SERVICE BULLETIN

No. SB-AG-78

Revision A: 02/09/2023

Horizontal Stabilizer Attach Channel Repair

Figure 2. Model of SBAG78-1 Locating Tool

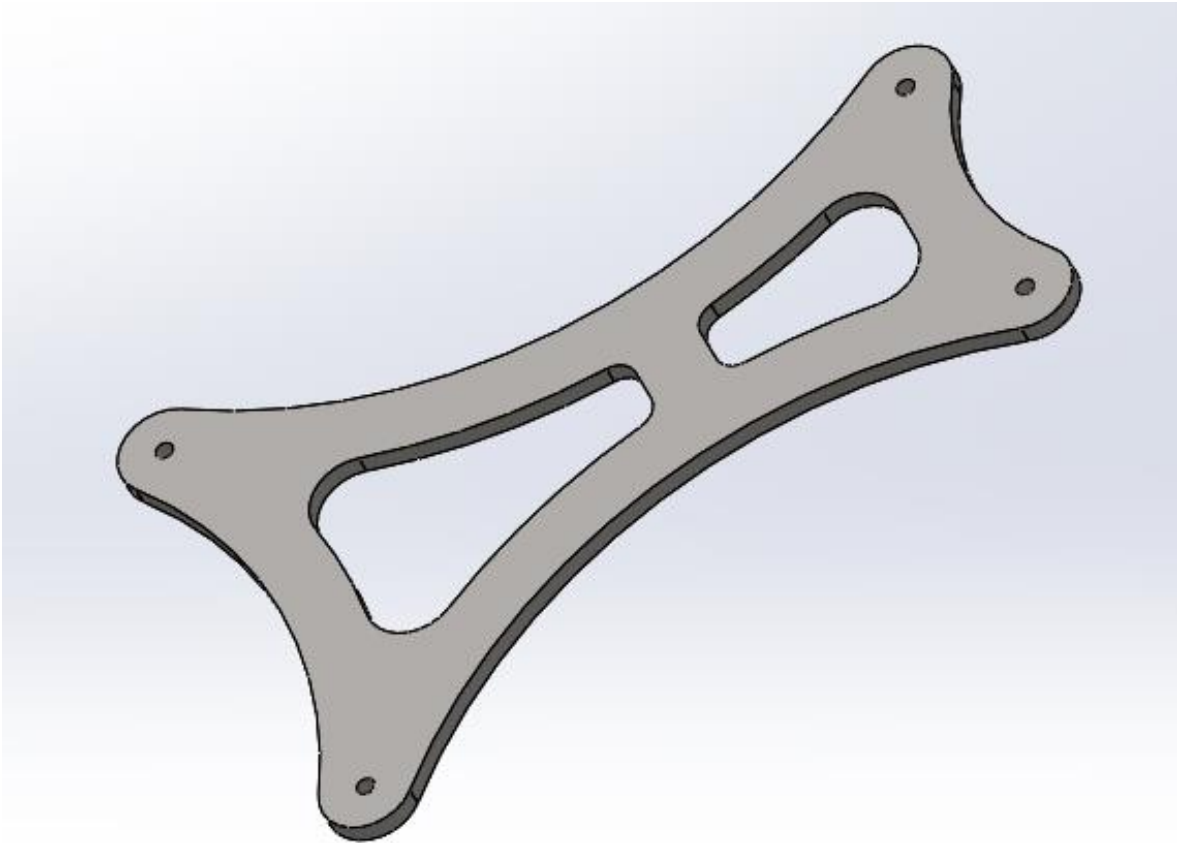
1. Temporarily fit and attach SBAG78-1 Locating Tool to the airframe's existing horizontal stabilizer attach channels as shown in Figures 2 and 3.
2. Verify the fixture's fit with both the horizontal stabilizer and the airframe's matching stabilizer attach channel fastener holes. Fasteners should install with minimal effort.
3. Remove fixture after fit verification.

Figure 4. Nut, bolt, washer, and 10962-2 (10962-3 on T660) Channel

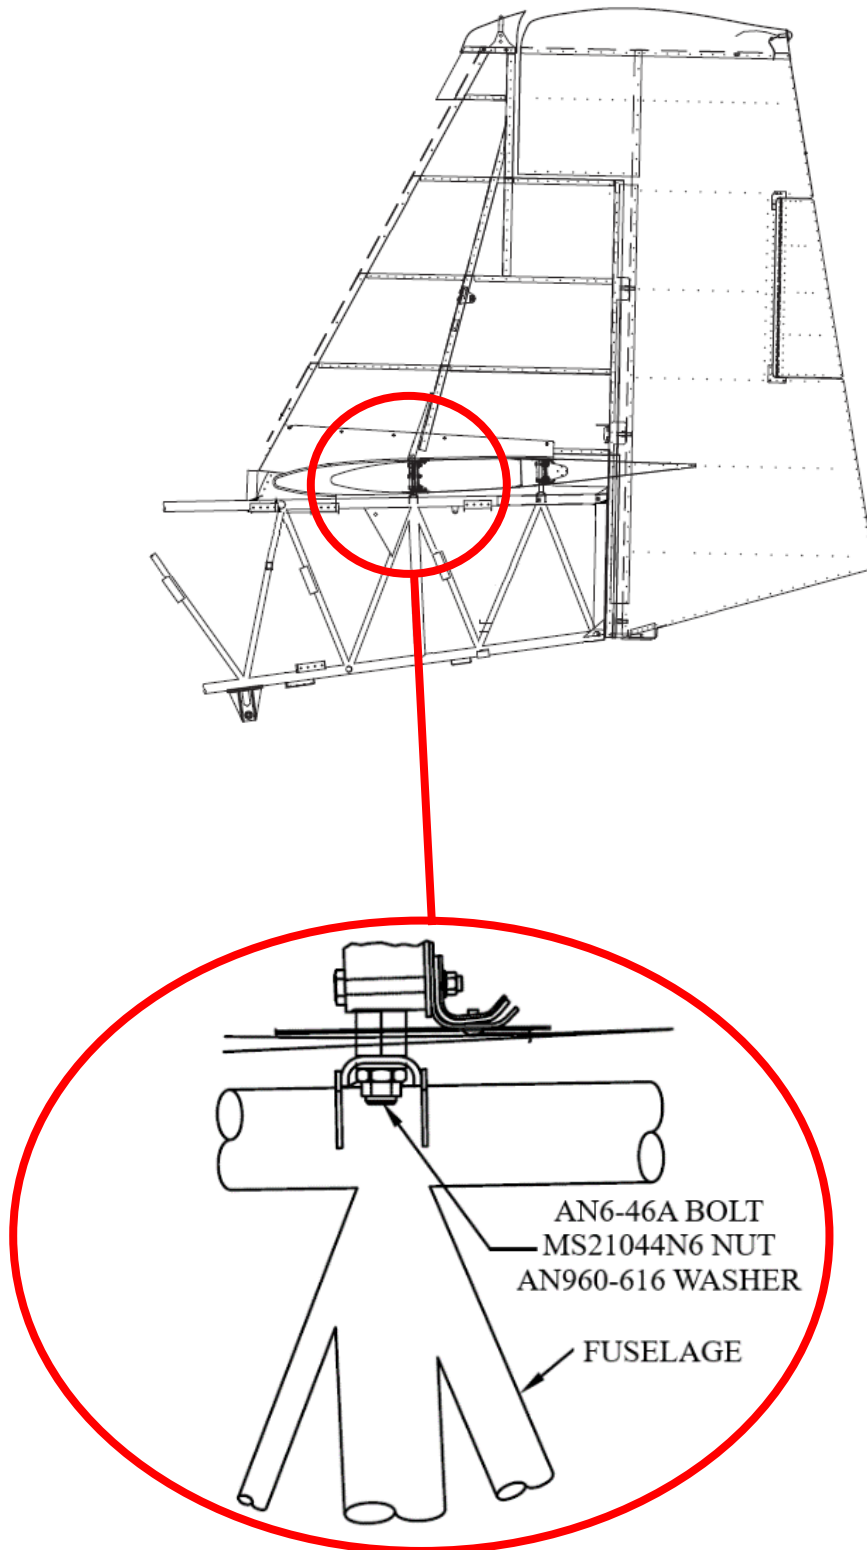
REMOVAL OF CHANNEL 10962-2/3

1. Prepare and fit welding blankets as required to protect aircraft from weld heat, grinding sparks, and swarf, and to collect and capture as much grinding swarf as possible.
2. Remove any flight control mechanism components that may potentially be contaminated by swarf.
3. Grind or saw to remove 10962-2 Channel (10962-3 on T660) (shown in Figure 4) and its gussets from the airframe longerons, transverse member, and vertical members. Use extreme care to avoid any damage to adjacent airframe members' parent metal. Leave welds .01 to .02 proud of parent metal's surface.

4. Clean area with commercially available acetone and re-inspect to ensure no further damage.
5. Locally remove finish from all areas within 1 inch of joints to be fused, assuring parent metal is undamaged in the process.

Figure 5: 534220003-003 Channel on Airframe

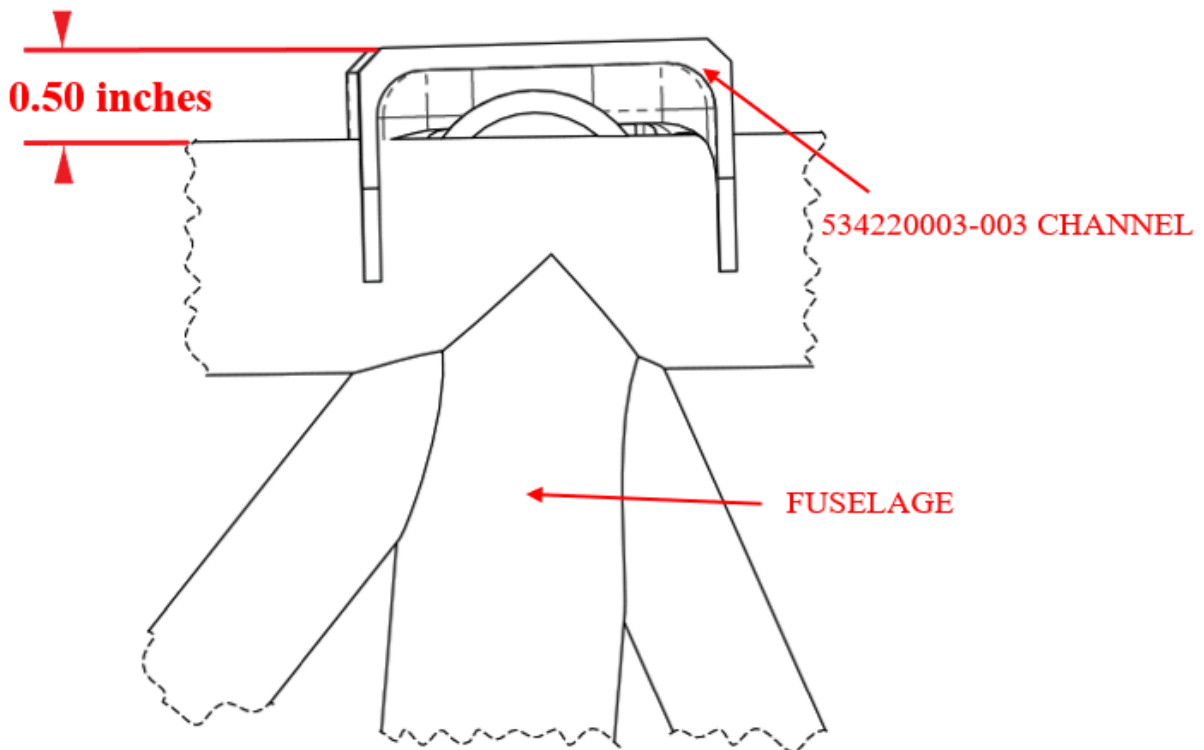
1. Check fit of new 534220003-003 Channel or 534220001-003 T660 Channel:
 - a. Use AN6 bolts to temporarily fasten 534220003-003 or 534220001-003 Channel to the SB78-1 Locating Tool as shown in Figure 4. Temporarily fit the supplied weld fixture to airframe's aft stabilizer attach channel in the same fashion.
 - b. Verify the 0.5" dimension (0.38" for T660) from channel's upper surface to top of longeron. Refer to Figure 5. The weld fixture's lower surface should lie flush on both the fore and aft attach channels.

1. Weld 534220003-003 or 534220001-003 Channel to airframe
 - a. Joining is to be accomplished by the Gas Tungsten Arc Welding (GTAW) process, also known as the TIG welding process.
 - Electrode: 2% thoriated tungsten
 - Filler Metal: E70S-2 Rod
 - Shielding Gas: 100% Argon
 - b. Tack-weld parts in a sufficient number of locations to assure stability for welding.
 - c. Order weld sequence and weld duration to prevent weld distortion.
